**HISTORIC PRESERVATION ADVISORY
COMMISSION
MEMORANDUM**

Meeting Date: February 11, 2026

RE: Planning Application 2025-0000084/HDR (Ferro Residence Historic Design Review); 10383 High Street (APN 19-080-015); Owner/Applicant: Paul Ferro, Ascend Architecture

Figure 2: Current Design, Front/North Elevation

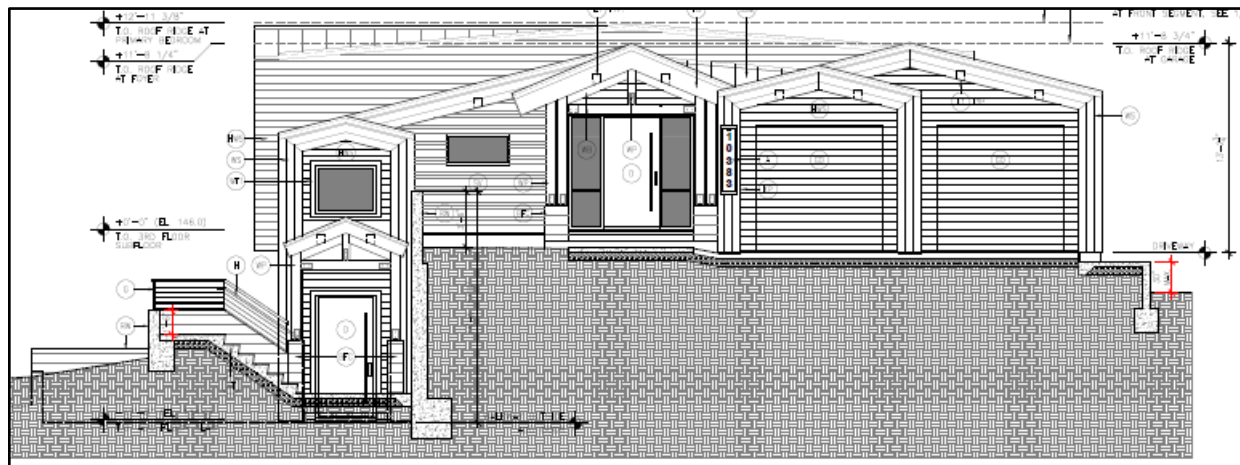
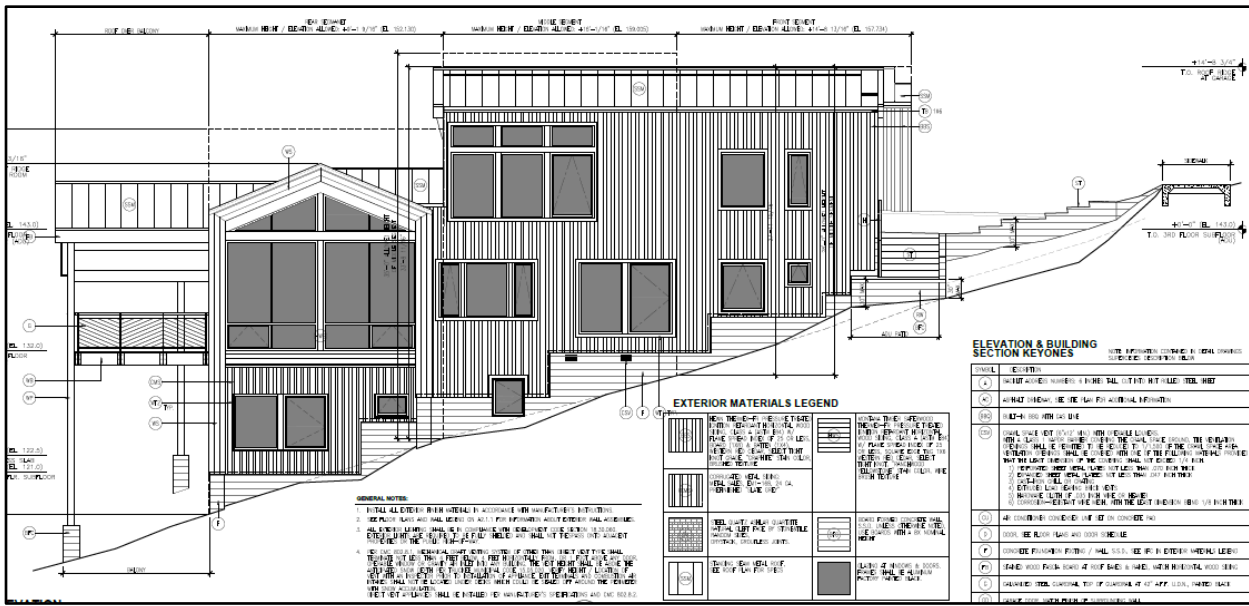
At the October 22, 2025 meeting, HPAC identified that the massing and scale was problematic and that the massing of the middle section appeared barn like. While the footprint of the structure remains the same, the height of the middle and southern thirds of the structure has decreased. As shown in Figures 2 and 3 in this memo, the massing on the left-hand side of the north elevation has diminished.

While some changes were made to reduce the mass of the structure, which included reducing the height, changing rooflines, changing the floor programming to reduce the mass behind the front façade, the majority of the mass of the structure is found in the front two thirds of the structure. The third segment of the building located at the southern end of the site steps down the hillside. However, the middle segment does not step down the hillside. It is the same height as the segment closest to

the street at the north side of the site. As a result, massing is not reduced substantially in the middle segment of the structure, and the middle segment does not reinforce the perception of the natural topography. While the High Street façade is one-story in character, the remaining elevations are two-to two-and-a-half stories in nature, which does not reflect the one and one-half stories found in the McGlashan Character Area. Therefore, the project's mass and scale would be inconsistent with Design Guide 3 in the McGlashan Area Character Addition.

Figure 4: Current Design, East Elevation

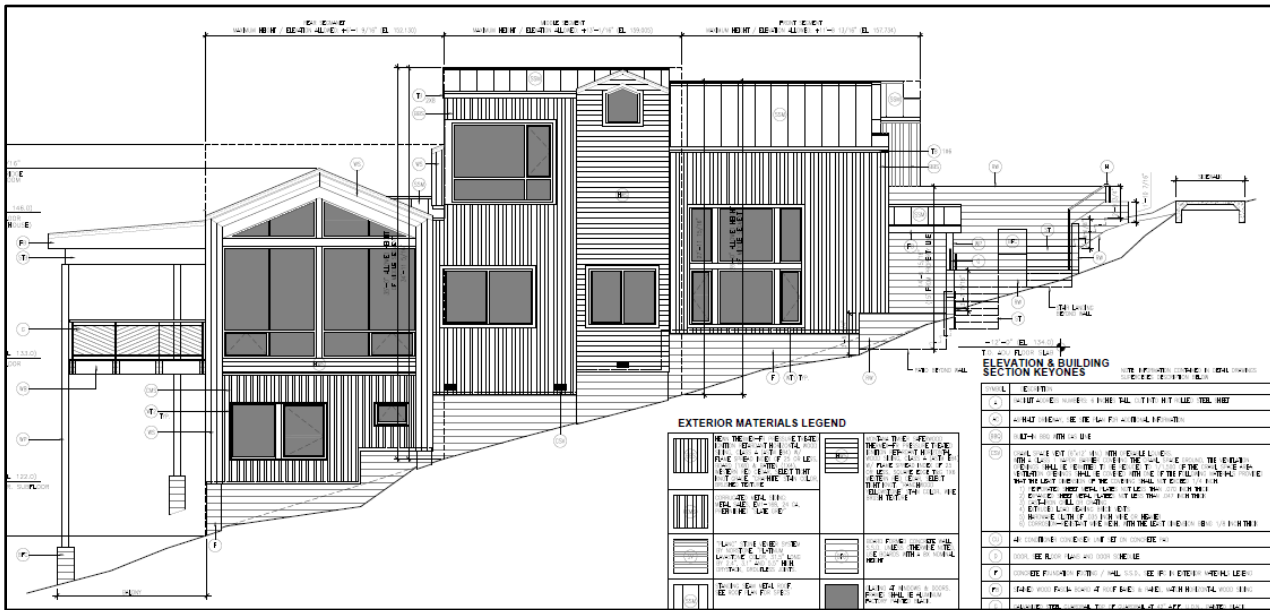
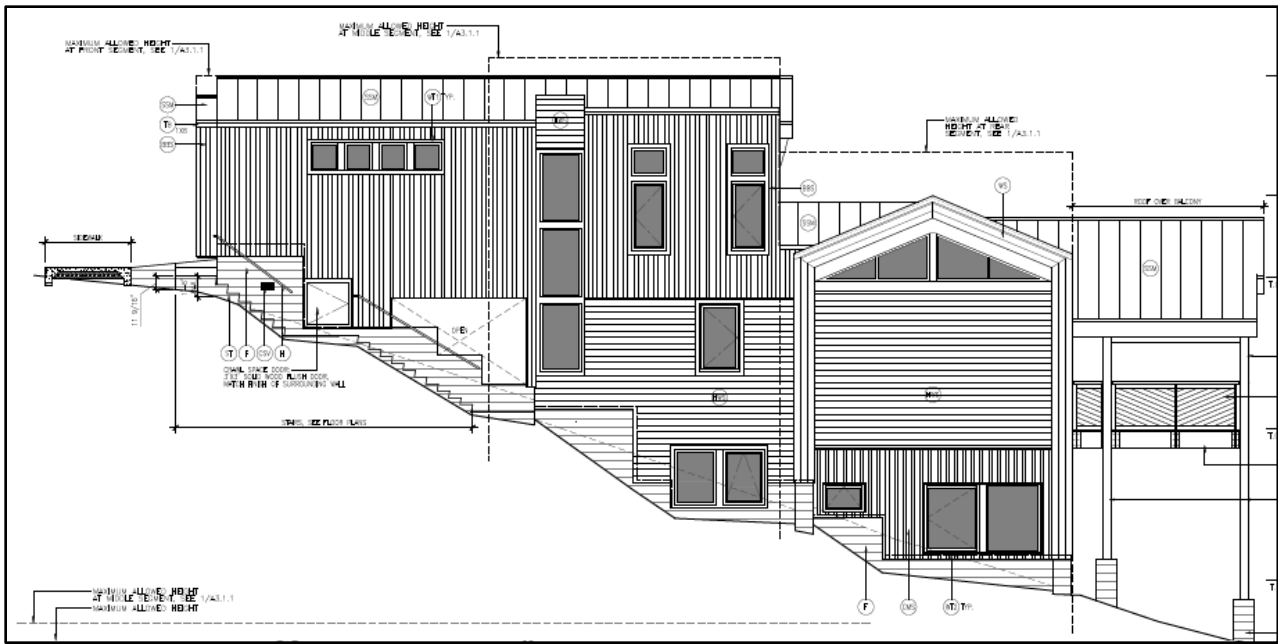
The structure is comprised of basic forms with a varying roofline. Rectilinear forms along the western and eastern façade frame the structure, with the exception of a large gabled window on the eastern elevation and corresponding gabled wall on the western elevation. Windows have been relocated to respond to floor plan changes and have been revised to have a more vertical proportion. Multi-gabled roof forms are found along the front façade, mid-section of the residence, and above the deck at the southern elevation. The long low sloped shed roof over the rear balcony was replaced with three dormer gable roofs with steeper slopes. Pitches of these gabled forms range from 1:12 to 3:12, and the material is proposed to be a metal seam, painted matte black. The height of the mid-section of the residence was reduced from 34'-11" to approximately 33'-8".

Figure 8: Current Design, Sout/Rear Elevation

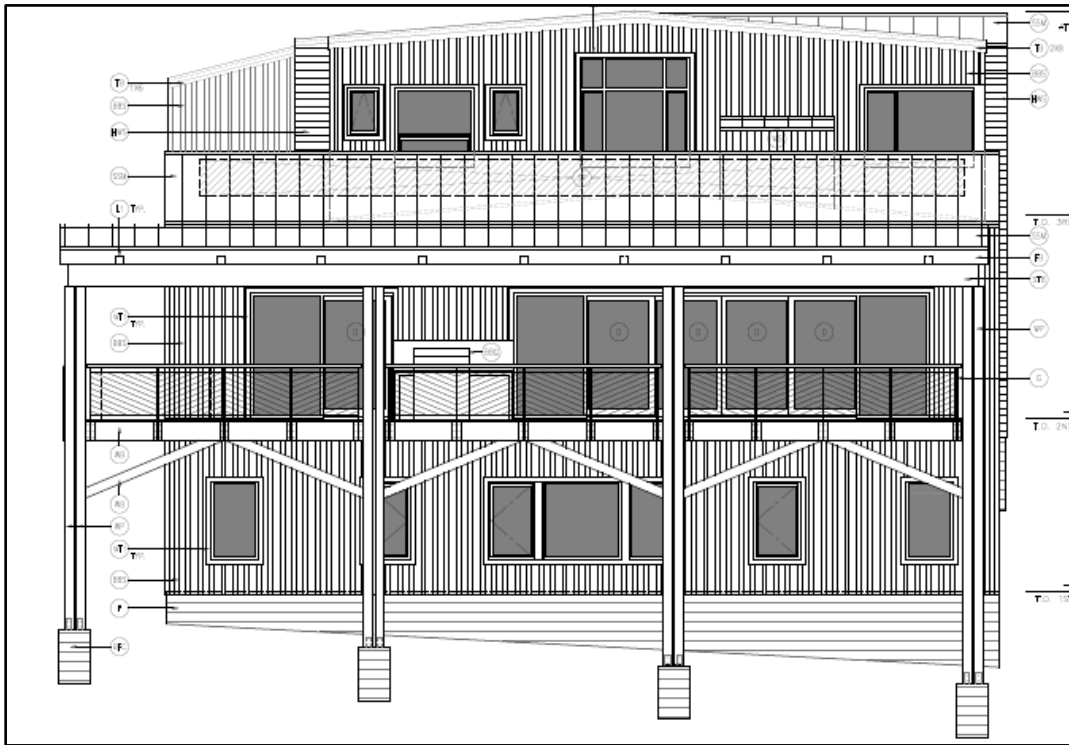
Rooflines have been revised from low pitched roofs to a gabled design. The long low sloped shed roof over the rear balcony was replaced with three dormer gable roofs with steeper slopes, making the south/rear elevation consistent with the many gable roofs of the neighboring buildings that face the downtown below. These gable roofs replicate the detailing of the exposed beams and king post truss found at the north/street elevation over the residence entry.
